**CHARTER TOWNSHIP OF VAN BUREN
PLANNING COMMISSION - VIRTUAL MEETING ON ZOOM
September 9, 2020
MINUTES**

**Crossroads South Trailer Staging
41873 Ecorse Rd
Preliminary Site Plan Review**

**Subject: VBT-20-006/Ashley Crossroads South Trailer Parking; Site Plan Review #2
Revised Site Plans Dated 6/16/20; Recd. by Township 8/11/2020.**

FISHBECK ENGINEERING
FEASIBILITY PRELIMINARY
PLAN REVIEW COMMENTS
8/27/2020

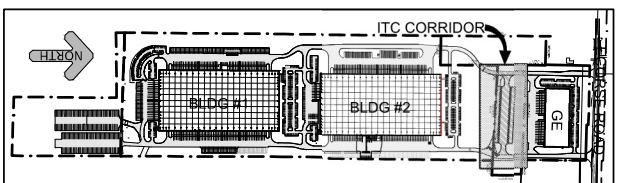
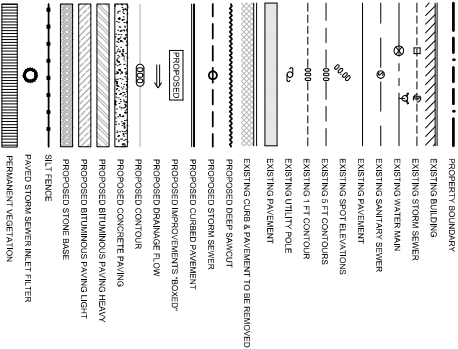
1. The applicant response letter dated July 31, 2020 indicates that the Storm Structure 7a will be replaced with a 7-ft diameter structure with sump in order to accommodate a new 12-inch concrete sewer. This new structure must be indicated on the plans.

1. Existing and proposed contours and slopes must be indicated, indicating the pre and post construction drainage patterns of the site. Indicate how the north side of the parking lot flows and how runoff will be collected.
2. Grading plans must be included, showing flow arrows with general slopes of the area, including the parking lot, verifying that the curb and gutter proposed is the correct application, and to also verify that minimum and maximum slopes/grades allowable by the Township Engineering Standards Manual are met.

Subject site

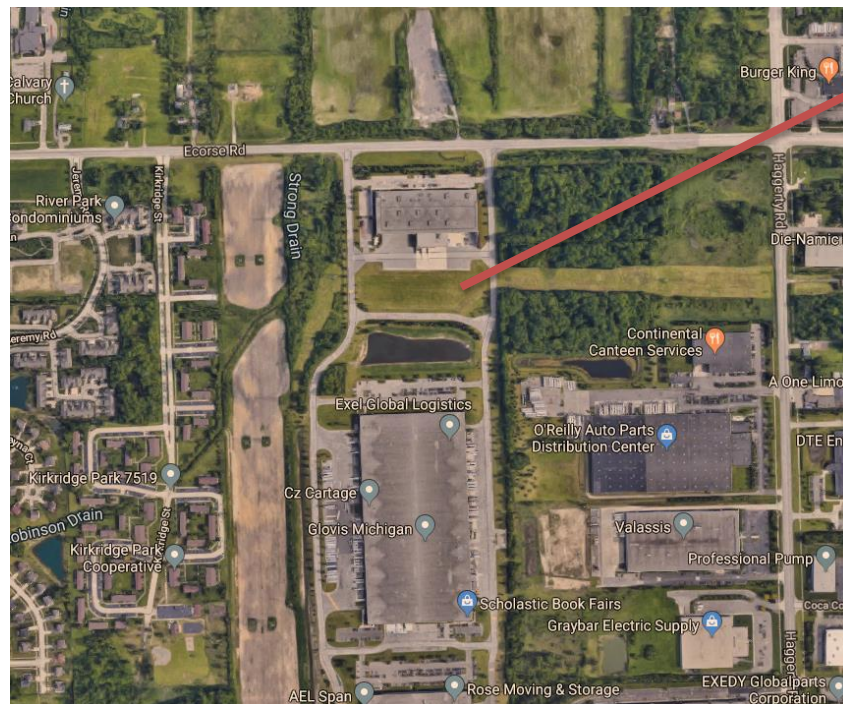
- 1. Zoning and Use.** The site is part of the larger ITC corridor that runs east-west and was recently rezoned from RM to M-1 (Light Industrial) District. The trailer parking is intended to serve the light industrial building with frontage onto Ecorse Road, Building No.3. Section 3.115 (B) of the Zoning Ordinance permits accessory uses which are incidental to the principal permitted use.
